**CITY OF MT. MORRIS
PLANNING COMMISSION AGENDA
July 15th, 2024
6:30 p.m.**

TO: City of Mt. Morris Planning Commission
FROM: Jason Ball, Senior Planner
Doug Skylis, Senior Project Manager
SUBJECT: 643 Walker Street and 630 West Mt. Morris Street
Conditional Use Application Review #2
DATE: November 23, 2021

Applicant:	Star Budz Provisioning Center LLC
Property Address:	643 Walker & 630 W. Mount Morris St.
Parcel ID:	57-12528015 & 57-12528014
Planning Commission Meeting Date	November 29, 2021

A-05

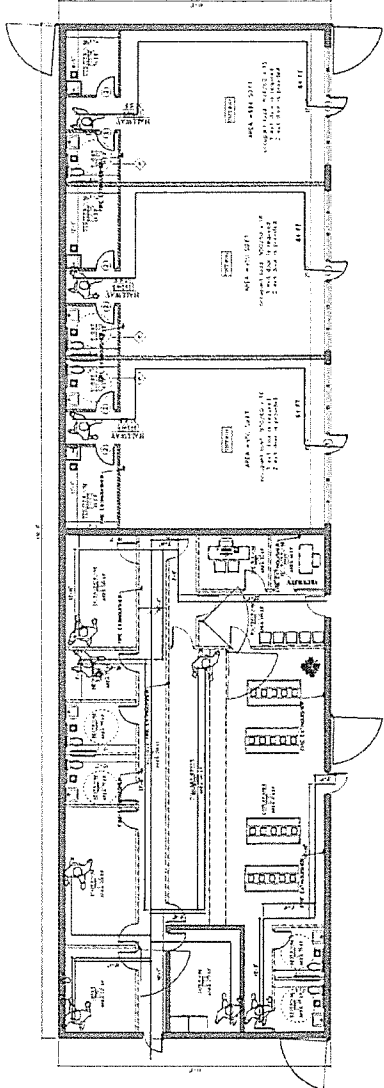
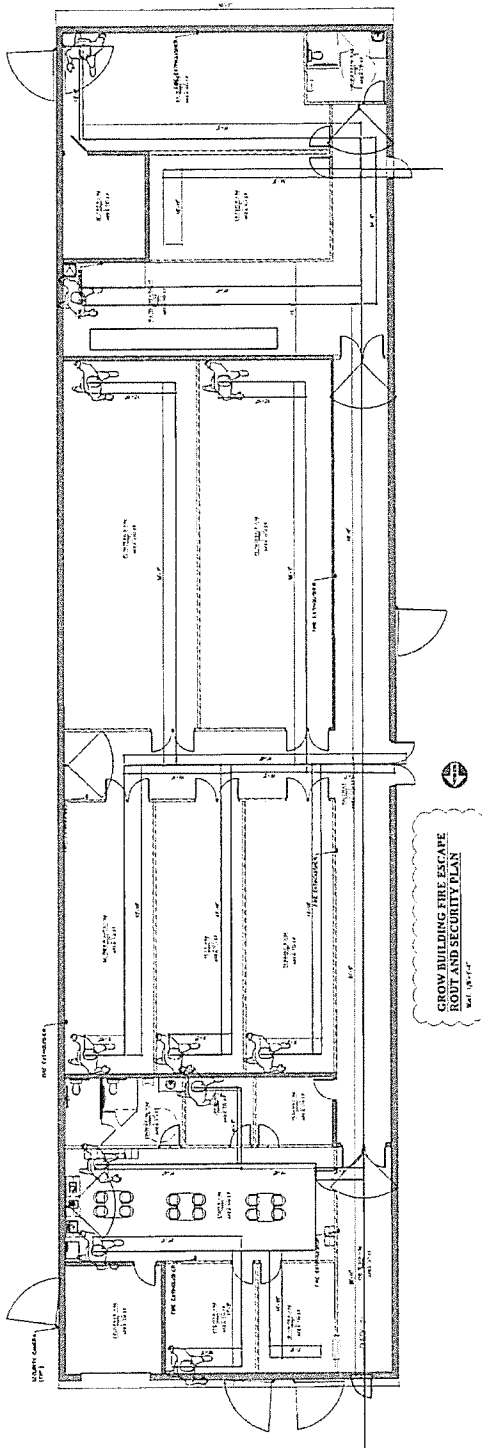
- ~~Clearly these are two different buildings yet the titles under each of them are the same. This needs to be corrected to confirm which building the title apply towards.~~ Building title has been revised.
- The applicant will be required to submit for and obtain approval from Genesee County Drain Commissioner's office for storm water drainage, water, and sanitary sewer services. **To be addressed with engineering plan review.**
